CONSTRUCTION OF
SIDEWALK / DRIVEWAY

The above hereby request permission to construct a: ☒ driveway / ☐ sidewalk located at 300 Cotton Ave Plot 98 Lot 25 to be constructed in accordance with the city's latest construction standards and specifications and adhere to the Ordinances of the City of New Bedford.

Driveway Review Form

Driveway Review

Sketch

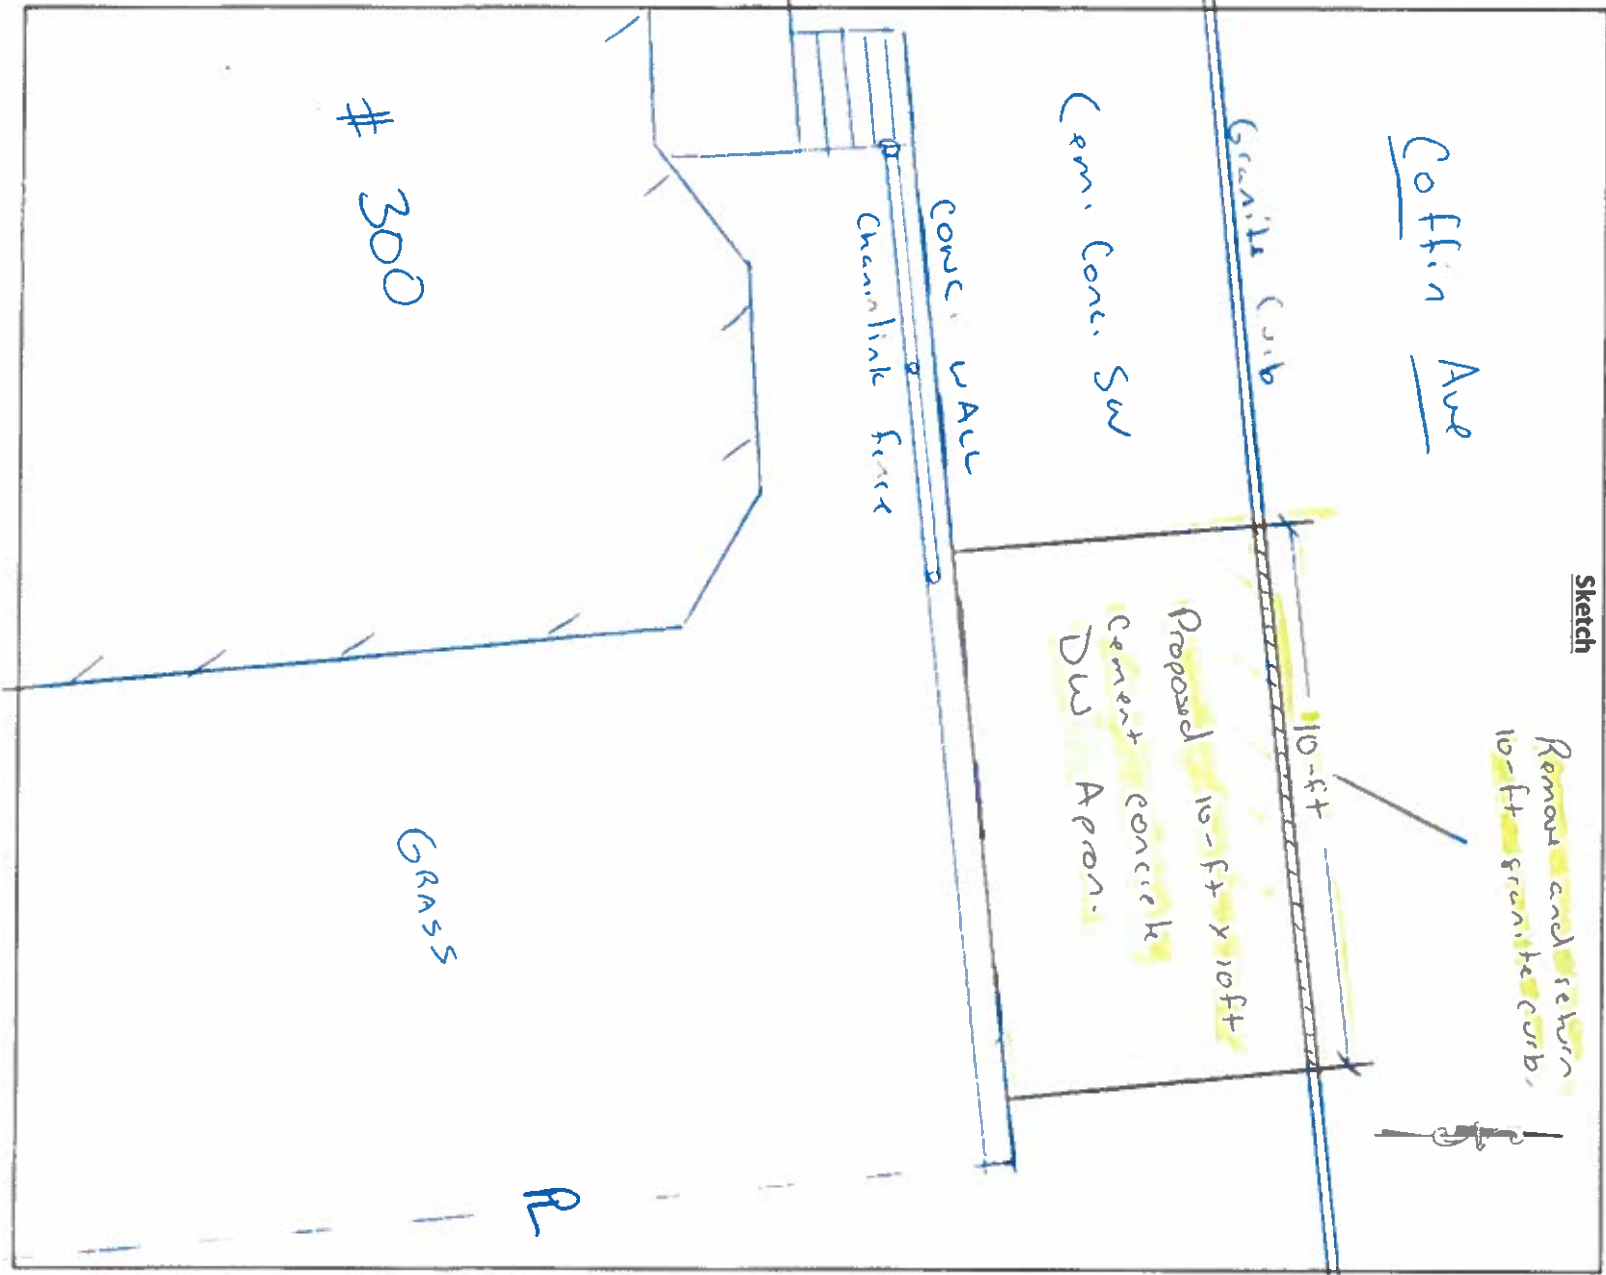
Plan Review Comments: : 1. Remove and return 10-ft granite curb.
2. Remove existing 10-ft x 10-ft cement concrete sidewalk.
3. Install new 10-ft x 10-ft cement concrete driveway apron in accordance with most current City of New Bedford DPI Construction Standards and Specifications manual.

Additional Inspection Notes: 1.Curb return above. 2.Remove existing 10-ft x 10-ft cement concrete sidewalk. 3.Install new 10-ft x 10-ft cement concrete driveway apron in accordance with most current DPI specs.

Remove and return
10-ft granite curb

Proposed 10-ft x 10-ft
concrete
Driv Apron
